Appl. No. : **09/196,658**
Filed : **November 19, 1998**

AMENDMENTS TO THE DRAWINGS

METHOD D APPARATUS FOR RECEIVING GPS/GLONASS SIGNALS

FIG. 5

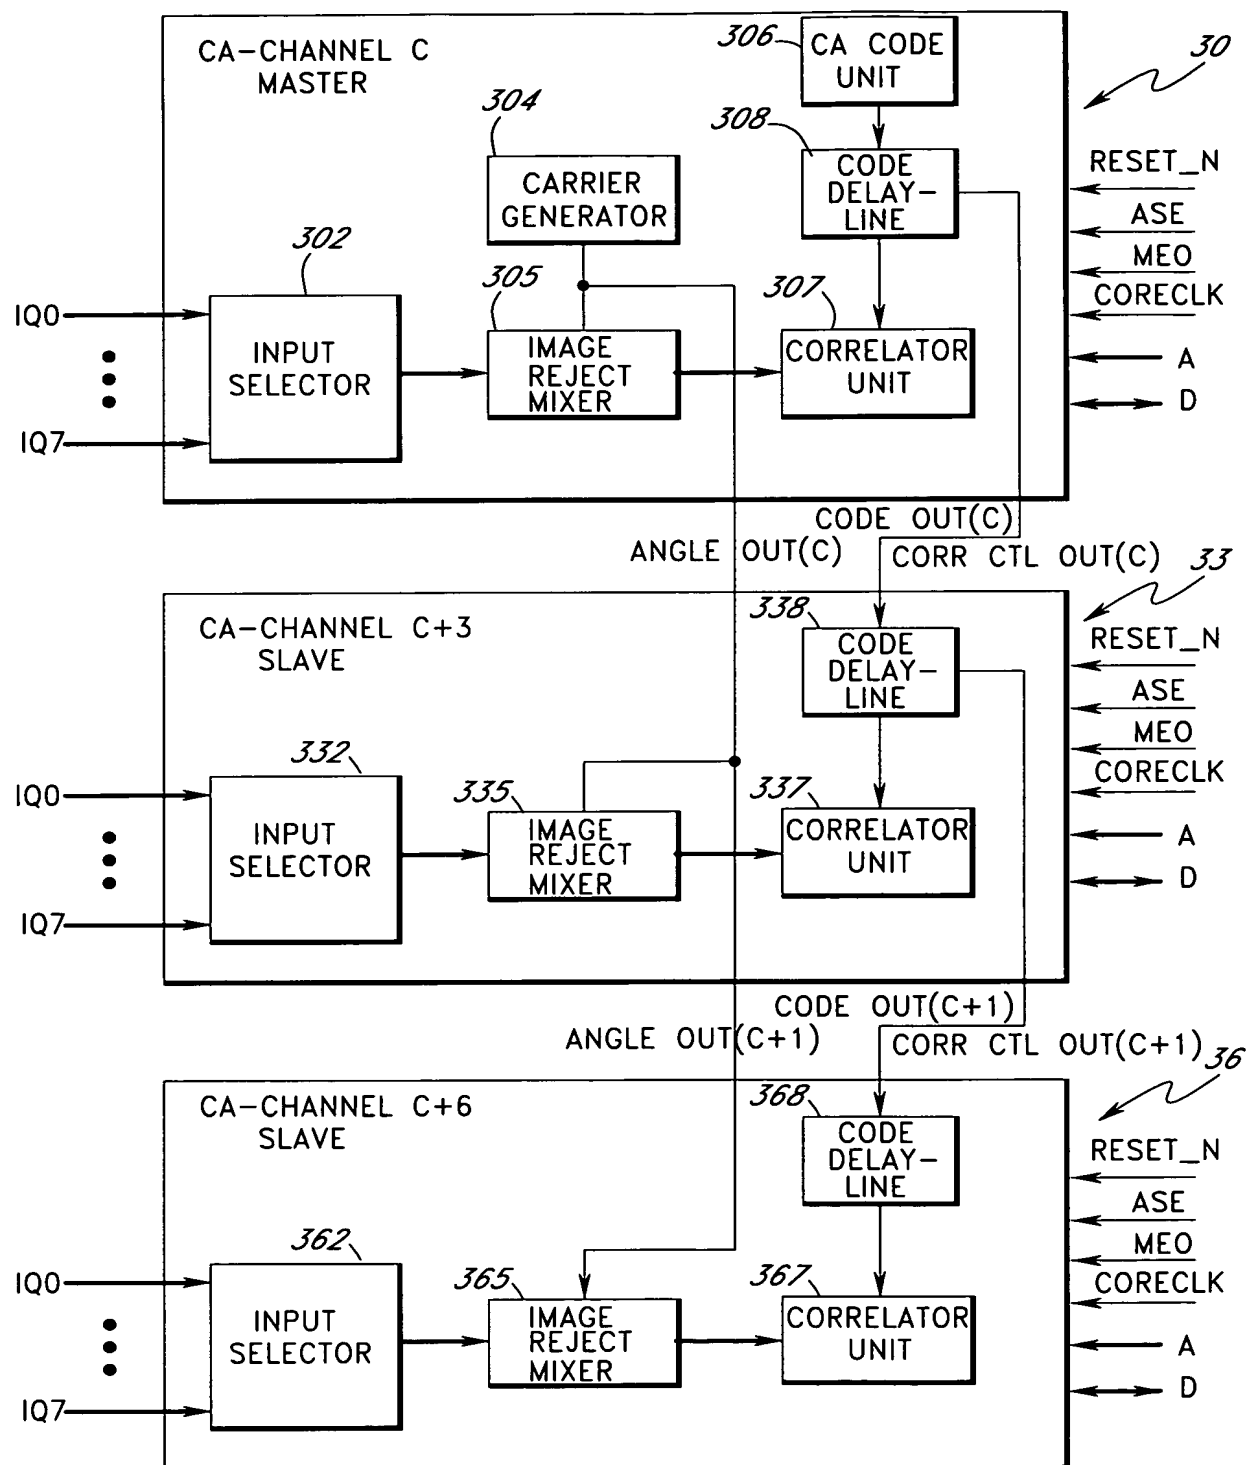
The attached sheets of drawings include changes to Figures 5 and 6. Each of the sheets, which includes Figures 5 and 6, respectively, replaces the original sheets including Figures 5 and 6, respectively. In Figures 5 and 6, the signals IQ and IQ7 have been amended to "IQ0-IQ7." In Figure 6, the correlator units 317 and 327 have been amended to the correlator unit (L1 demodulator) 317 and the correlator unit (L2 demodulator) 327, respectively.
